REVISION TRANSMITTAL

This sheet transmits Revision 1 to MEB-27-02, which:

FLIGHT CONTROLS - ELEVATOR TRIM-TAB PUSH-PULL TUBE HARDWARE REPLACEMENT

MEB-27-02
Page 1 of 8

Figure 1. Elevator Trim-Tab Push-Pull Tube Hardware (Sheet 1)

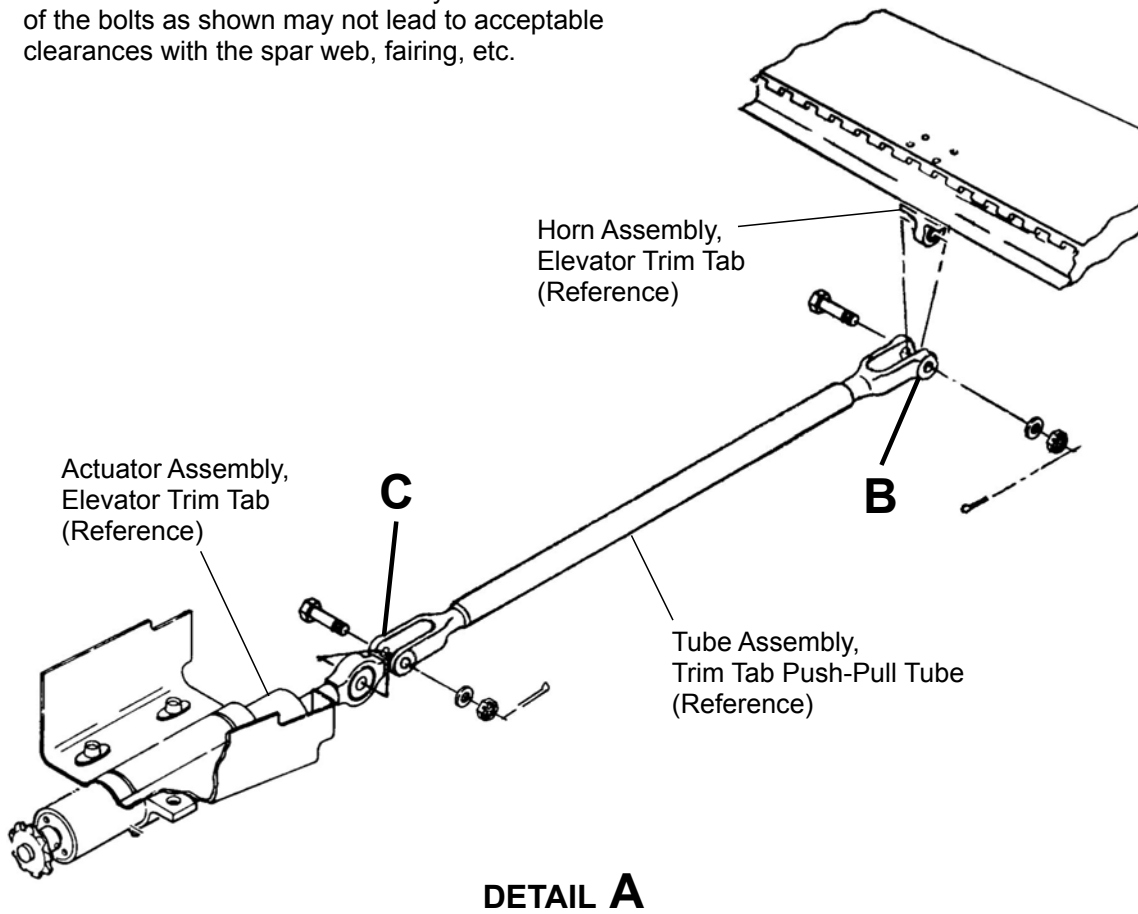
4. (Refer to Figure 1, Sheet 1 and Sheet 2.) Install the NAS464P3-8 Bolt, NAS1149F0332P Washer, MS17826-3 Nut and MS24665-132 Cotter Pin in the elevator trim tab actuator rod end to push-pull tube connection as follows:

- NOTE:** It is permissible to substitute the NAS464P3-X bolt with a NAS6203-X bolt.
 - A. (Refer to Figure 1, Sheet 1 and Sheet 2.) Install the NAS464P3-8 Bolt in the elevator trim tab actuator rod end to push-pull tube connection in the orientation (i.e., bolt head inboard or outboard) which yields the greatest clearance with the spar web cut-out and any other structures.

- NOTE:** It is permissible to substitute the NAS464P3-X bolt with a NAS6203-X bolt.
 - B. Install the NAS1149F0332P Washer and MS17826-3 Nut onto the NAS464P3-8 Bolt.

- C. Torque the MS17826-3 Nut 12 Inch-Pounds, if a castellation of the nut does not align with the cotter pin hole in the bolt, continue tightening to the next alignment position up to 20 Inch-Pounds.

- D. Make sure a minimum of one full bolt thread is protruding from the castellated nut.
 - E. Install the MS24665-132 Cotter Pin.
5. (Refer to Figure 1, Sheet 1 and Sheet 2.) Remove the nut, washer and bolt from the elevator trim actuator push-pull tube to elevator trim tab horn.

DETAIL B

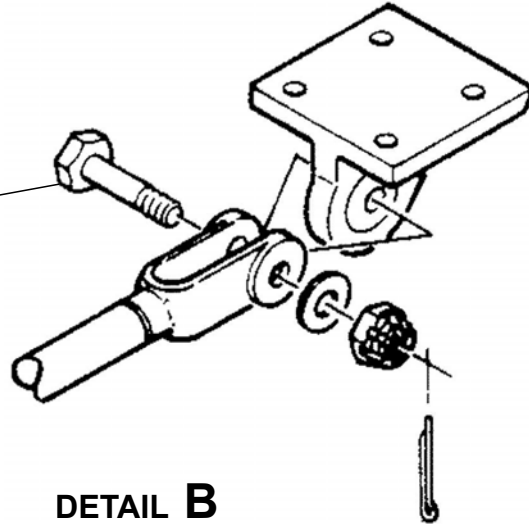
- NOTE:** The bolt grip length may be adjusted to the next longer grip length (NAS464P3-9) to permit proper installation of the castellated nut and cotter pin. This may require extra washers (NAS1149F0316P and/or NAS1149F0332P) for proper alignment of the castellated nut cotter pin slot and the cotter pin hole in the bolt.

NAS464P3-8 or
 NAS464P3-9
 Bolt
 (1 Required)
 NAS1149F0332P
 and/or
 NAS1149F0316P
 Washer
 (1 or More as Required)
 MS17826-3
 Nut
 MS24665-132
 Cotter Pin
 (1 Each Required)

DETAIL C

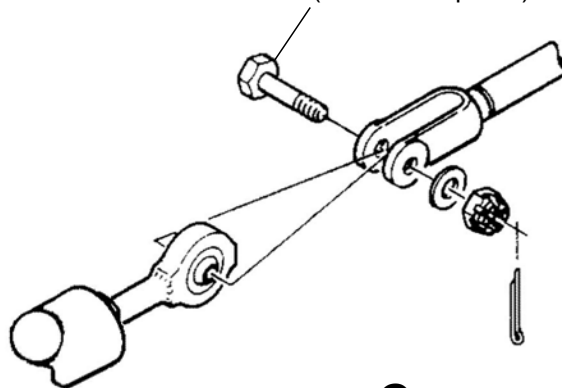
- NOTE:** The bolt grip length may be adjusted to the next longer grip length (NAS464P3-9) to permit proper installation of the castellated nut and cotter pin. This may require extra washers (NAS1149F0316P and/or NAS1149F0332P) for proper alignment of the castellated nut cotter pin slot and the cotter pin hole in the bolt.

NAS464P3-8 or
 NAS464P3-9
 Bolt
 (1 Required)
 NAS1149F0332P
 and/or
 NAS1149F0316P
 Washer
 (1 or More as Required)
 MS17826-3
 Nut
 MS24665-132
 Cotter Pin
 (1 Each Required)
